UCLH

Phase 5 ENT Treatment Centre

Planning MMA Shropshire Place Elevation

Project Originator Vol. Level Type Role Number  
P5 - BMJ-001-XX-DR-A- 2192

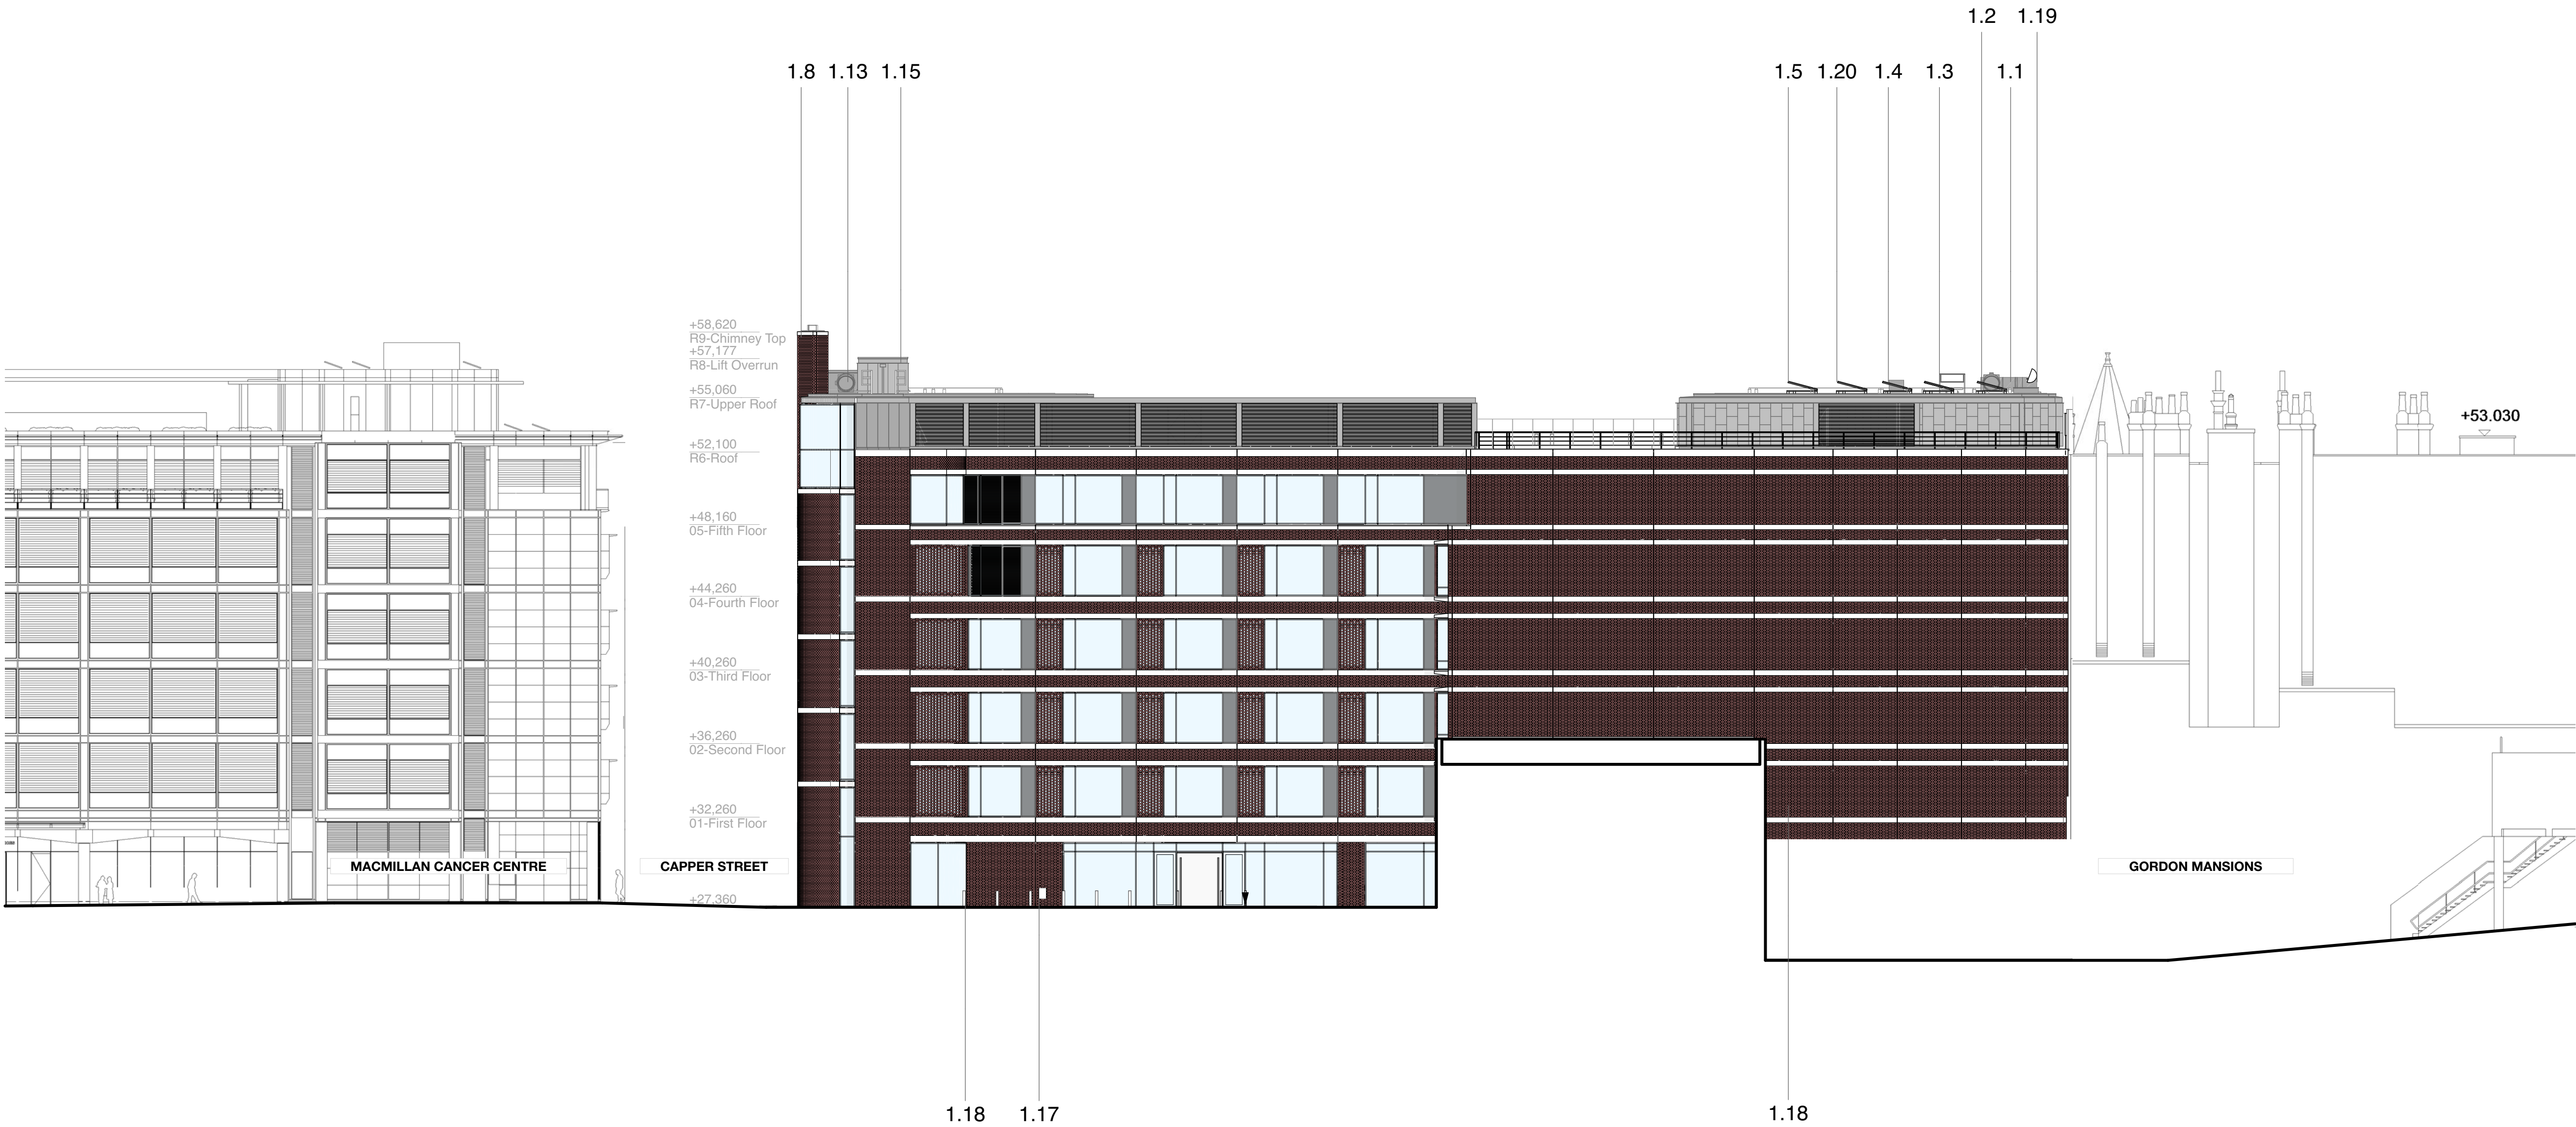
- 1.1 - Lift overrun removed
- 1.2 - South Core smoke depressurisation duct reconfigured
- 1.3 - Guardrail added to access hatch for improved safe access

- 1.4 - Toilet extract flue added
- 1.5 - Position of PVs reconfigured and profile lowered
- 1.6 - Removal of access door through glass balustrade
- 1.7 - Addition of housing for North Core smoke depressurisation duct

- 1.8 - Chimney flues added
- 1.9 - Escape door changed to flat metal panel doors to provide thermal performance
- 1.10 - Door arrangement to meet UKPN requirements

- 1.11 - Sheffield Hoop bike stands added
- 1.12 - Mullions added due to glass panel size restrictions
- 1.13 - North Core smoke depressurisation duct reconfigured

- 1.14 - Roller shutter amended with open grill sections to provide required fresh air flow
- 1.15 - Minor amendments to access ladders
- 1.16 - Bollards added to protect pavement grill

- 1.17 - Dry Riser moved
- 1.18 - Configuration of panel joints amended for buildability
- 1.19 - Satellite dish & aerial added
- 1.20 - Louvre increased to provide required air flow

P02 Galvanized trim omitted from bottom of lift 4 overrun GP MH HG 05/02/2019
